5 CHANNELS DIFFERENTIAL 24BIT ADC

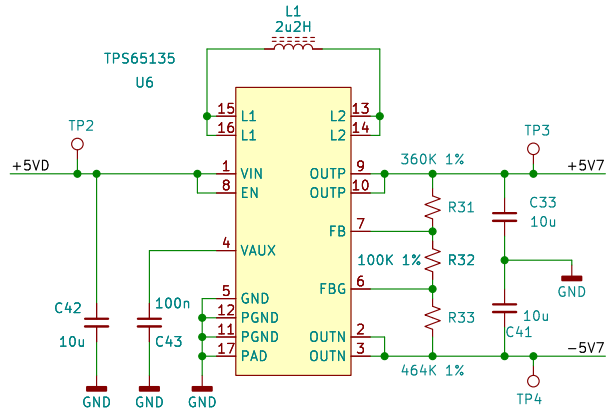
TODO: consider to move the thermistor inputs to a separete board due to ADC internal crosstalk.

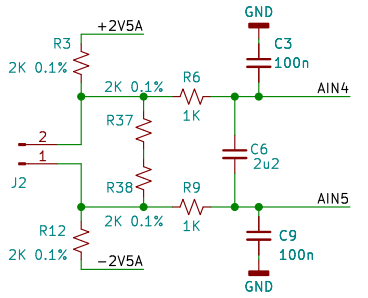
TODO: Added silk screen area for serial number.
